BULLETIN: CA-SB-17-70-13  
DATE: 5/22/70  
PAGE: 1 OF: 1

## SERVICE BULLETIN

SUBJECT: 17 SERIES OIL FILTERS/AA,BZ,CZ,DZ COMPRESSORS

PART NO. 17B2005

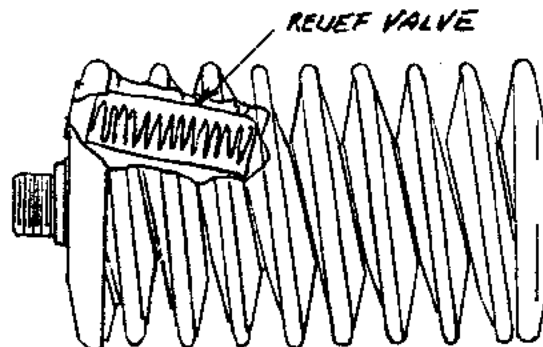
To advise that the existing replacement oil filter element (Carrier Part No. KH19BZ005) will not fit into the old style 17 Series AA,BZ, CZ, and DZ seal oil reservoirs.

The filter for the 17 Series AA,BZ,CZ, and DZ compressors required a threaded spud which screws into the reservoir casting.

The present replacement oil filter (Carrier Part No. KH19BZ005) is used on both the AA,BZ,CZ,DZ and the 17M,P,S seal oil reservoir. This element does not have the necessary threaded spud connection on the bottom of the filter cartridge. The 17M,P,S seal oil reservoirs contain a non-threaded hole which is larger than the threaded hold in the old AA,BZ,CZ and DZ types. The present cartridge, therefore, will not fit the present AA, BZ,CZ and DZ oil reservoirs.

When an oil filter element for the old style AA,BZ,CZ and DZ needs replacement, order Part No. 17B2-005. This filter has the threaded spud which will fit easily into the connection in the oil reservoir.
